# Turbine layout micro-siting bat specialist comment, and Bat Mitigation Action Plan for inclusion into the updated EMPr

**For the Sutherland Wind Energy Facility (WEF), Northern &  
Western Cape Provinces, South Africa**

**Ref: R-2212-53**

**Figure 2.1:** Micro-sited turbine layout in relation to the revised bat sensitivity map. Shaded red = High bat sensitivity; Red line = 200m high bat sensitivity buffer; Shaded yellow = Moderate bat sensitivity; Yellow line = 150m moderate bat sensitivity buffer.

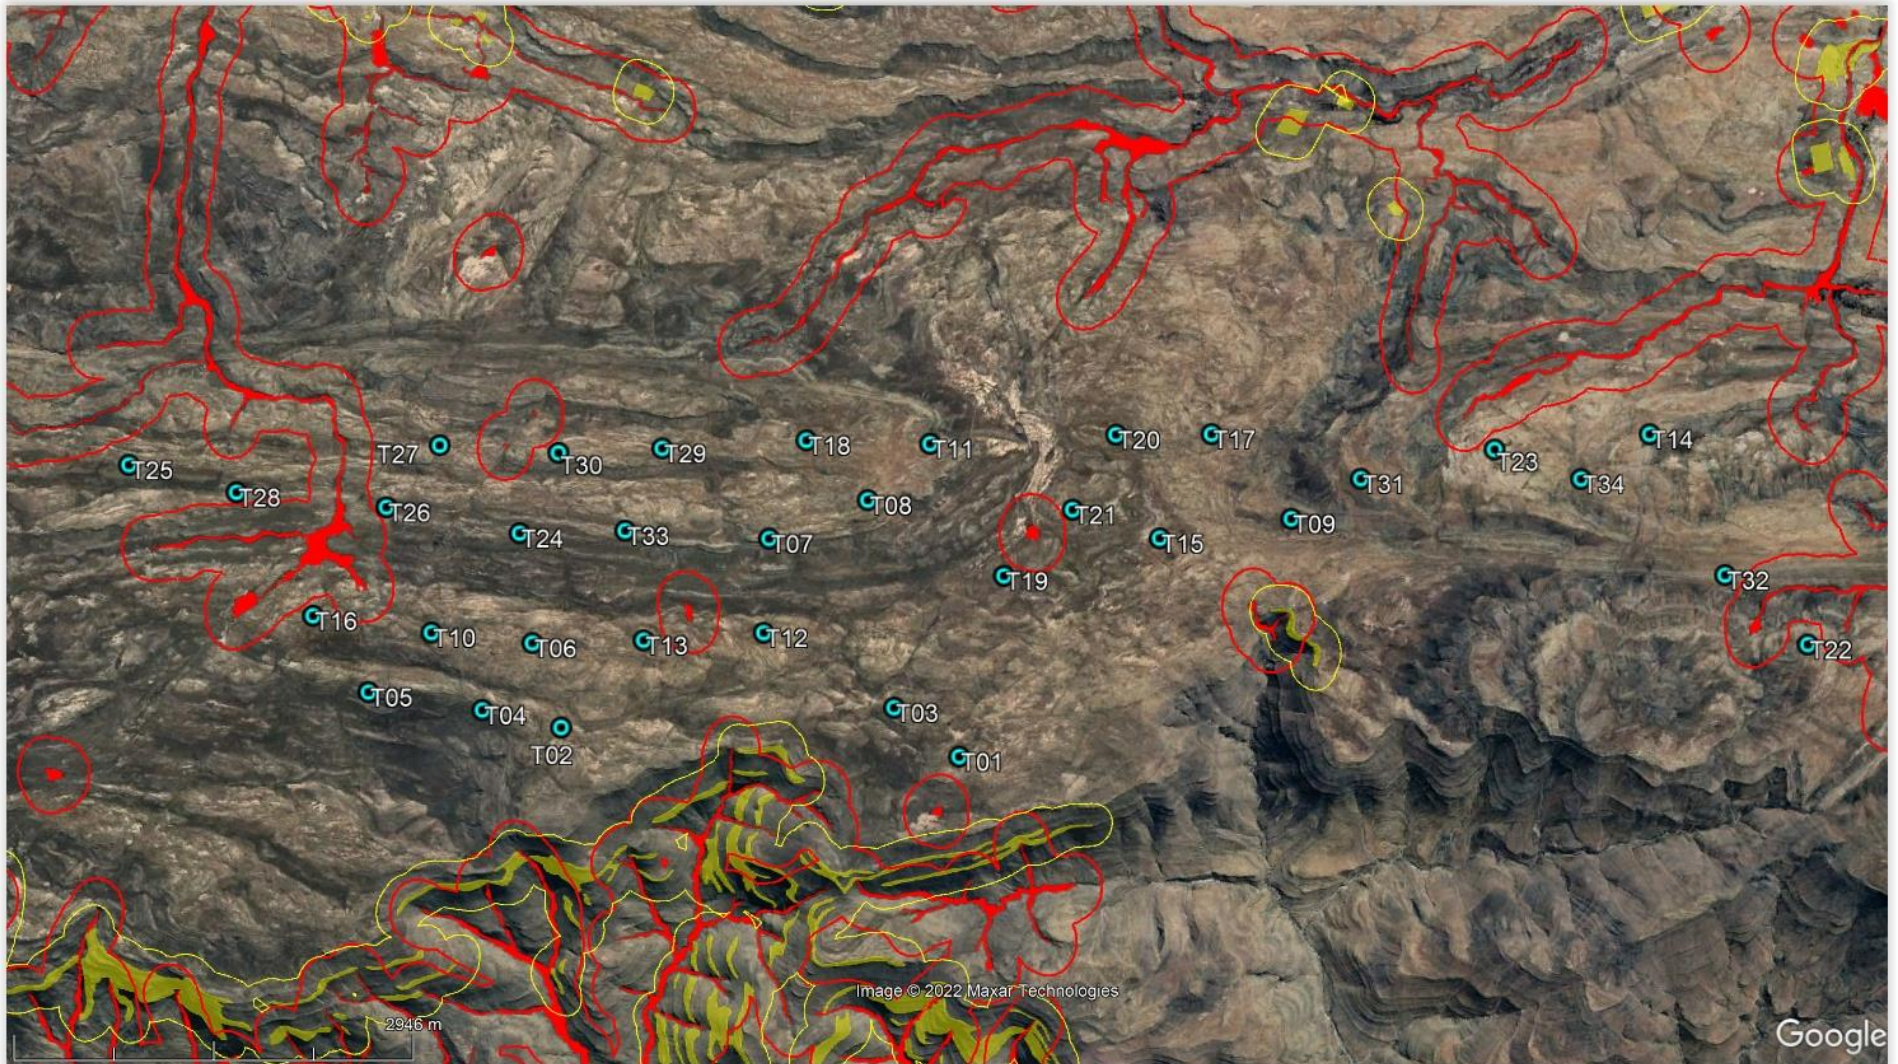
**Tables 2.1 & 2.2** below describes the implications of the sensitivity categories for the different infrastructure types of the WEF. No turbine blades are allowed to intrude into the high bat sensitivity buffer areas, therefore based on an 86m blade length, all turbine bases must be 86m or more from the edge of the 200m high bat sensitivity buffers indicated in **Figure 2.1**.

Based on a rotor diameter of 172m (i.e., 86m blade length), **no turbines or turbine blade overhang are intruding into the high bat sensitivity areas or their buffers.**

**The proposed microsited turbine layout respects the bat sensitivity map, and no turbines blades are intruding into any high bat sensitivities or their associated buffer areas.**

Animalia has **no objection to the proposed microsited final turbine layout**, on condition that this mitigation action plan is incorporated into the EMPr and is adhered to.
